Memo:

Re: ZBA 22-2008; 3095 Cedarbrook Road

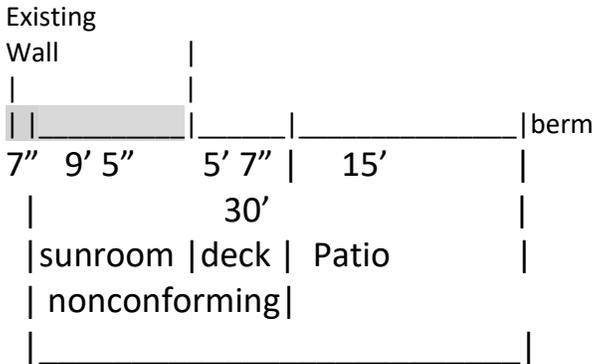
The Survey map in your packet shows a brick patio which appears to be taking up the depth of the 15' drainage easement. I have attached a picture of the petitioner's back yard. The fence that you can see in the photo was installed by the neighbor to the left of 3095 Cedarbrook. According to the Map of Survey the distance between the rear lot line and the wall of the new Sunroom would be 20' 7" and the patio constitutes 15 of those feet. This would mean that there will be 5' 7" of deck space before the wall of the proposed sunroom. Comparing the Map of Survey with the photo that I have provided does not seem to match exactly. The Map appears to show what will be after they finish construction

and not what is there now. In addition, the map does provide any data regarding the topography. The photo shows the parts of the berm outside of the rear lot line.

Notice that the photo shows a patio that is not necessarily brick and does not appear to be flat. It is not clear from the petition or the photo how much slope is involved in the patio or whether this whole section of the yard (deck and patio) is impermeable or not. The photo should give you an idea of where the sunroom would be and how much of the required open space would be devoted to impermeable surface. Although there is no record of a permit for the existing patio, neighbors think that this patio was installed in about 2009. At least two neighboring homes had to hire a company to lay drains in their yards to accommodate water that began to collect in their yards following the construction of the patio. Also, it should be noted that the survey shows that the patio encroaches into the yard of the neighbor to the left and onto the park property north of the owner’s lot.

It is difficult to determine in the picture just how far the sunroom will protrude into the yard or if the measurements provided are accurate. However, this schematic shows that Sunroom will take up 32% of the depth of the rear yard.
